POWER PLANT - ENGINE - POWERPLANT - INTRODUCE REVISED CLIPPING REQUIREMENTS AT CLIPPING
POINT CP1092 - CATEGORY CODE & - MOD.ENG-71-0105

V2500-ENG-71-0105

Location of the Scavenge Oil Tube and the Clipping Position 1092
Fig.1

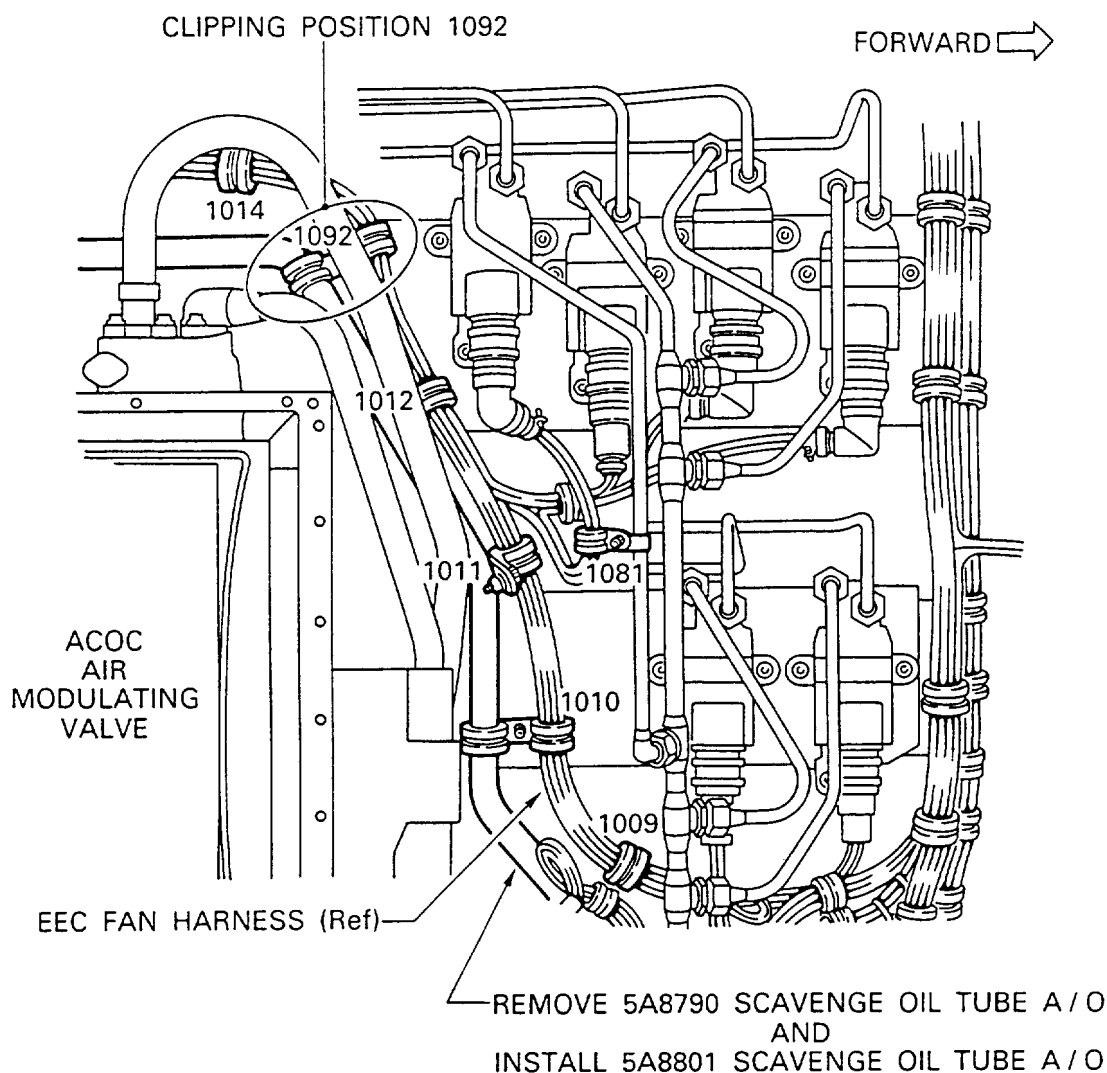
Bending of Lugs on Scavenge Oil Tube and rotation of clipping at CP1092 which holds the EEC Fan Harness could occur. This could potentially cause the chafing of harness.

- (a) A New Scavenge Oil Tube A/O which has the strengthened six lugs has been introduced (See Figure 1).
- (b) With new configuration of the Scavenge Oil Tube A/O, the clipping configuration at CP1092 is changed (See Figure 2).

- (1) Install 5A8801, Scavenge Oil Tube A/O, to the engine by the approved procedures in the Engine Manual, 72-00-32 Installation.
- (2) Install the bolts, the washers, the clips and the nuts at the clipping positions CP0594, CP1009, CP1010, CP1011, CP1012, and CP1014, and torque the nuts by the approved procedures in the Engine Manual, 72-00-32, Installation.
- (3) At CP1092, install 4W0104, Bolt, JM44LC39H109RG, Clamp, and 4W0001, Nut, to the EEC Fan Harness and the Lug on 5A8801, Scavenge Oil Tube (Refer to Figures 1 and 2). Torque the Nut to 36 - 45 lbfin (4 - 5 Nm).
